# BWR OWNERS' GROUP

BWROG-13014  
February 19, 2013

**SUBJECT:** BWROG ECCS Suction Strainer Program  
Closure of Technical Issue 12

Issue No. 12 – Spherical Zone of Influence – Closure Justification

Figure 1: Target Outside Spherical ZOI and Inside Directed Jet

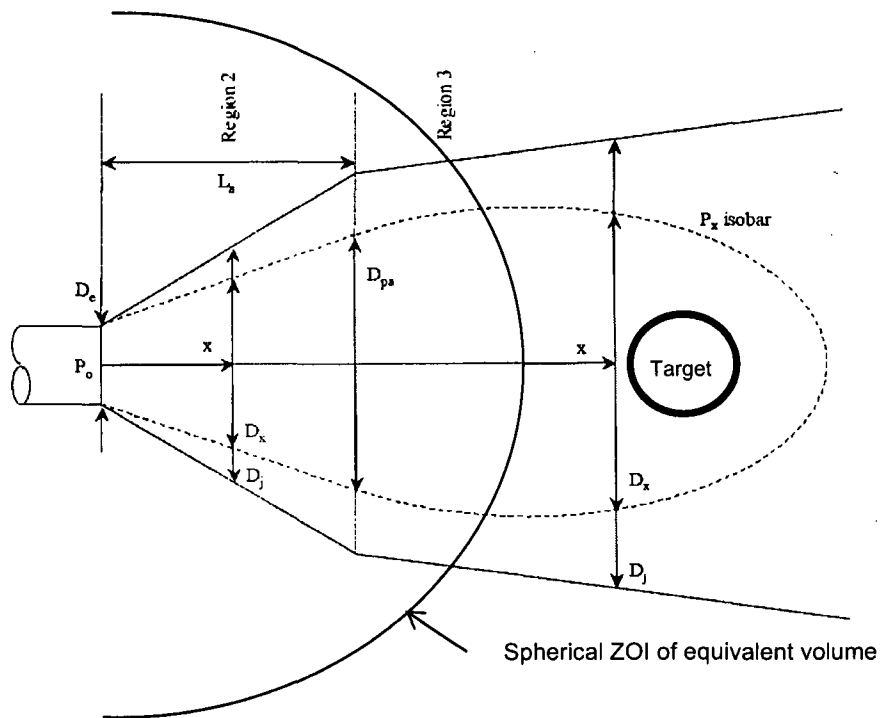
The NRC's concern is that, while a spherical ZOI may have maximized the quantity of debris, it may have precluded selection of a lesser amount of more problematic debris, such as micro-porous or calcium silicate insulation. Such problematic debris materials could be outside the spherical ZOI, but within the ZOI of a directed jet (see Figure 1).

We agree with the NRC staff on the conservatism inherent in the development and application of the spherical ZOI (e.g., reflection, energy dissipation, etc.) and also offer the following additional conservatisms relating to debris sources outside the sphere but within a directed jet:

1. Regarding calcium silicate problematic insulation, the radius of the BWR spherical ZOI is 6.4D (D is expressed in pipe diameter) and larger than the PWR ZOI of 5.45D with higher operating pressures and temperatures.

2. The directed jet theory assumes the break is fully offset with no interference from either the opposing jet or any structures with the effluent hitting a line of site target greater than 24 feet away (12D or 24 feet is the radius of the spherical ZOI associated with Min-K and Microtherm, and assuming a 24 inch pipe break).

While the BWROG understands the NRC staff's concern over these potentially problematic materials, there is no intent by the BWROG to 1) develop new guidance on the size and shape of a directed jet ZOI, or 2) to specifically exclude or ignore problematic debris sources that could, if destroyed, transport to the ECCS suction strainer. The resolution strategy outlined on the BWROG slide 13 mentioned above was prepared in the event the NRC staff chose to revise its position on the acceptability of the spherical ZOI, which they have not.
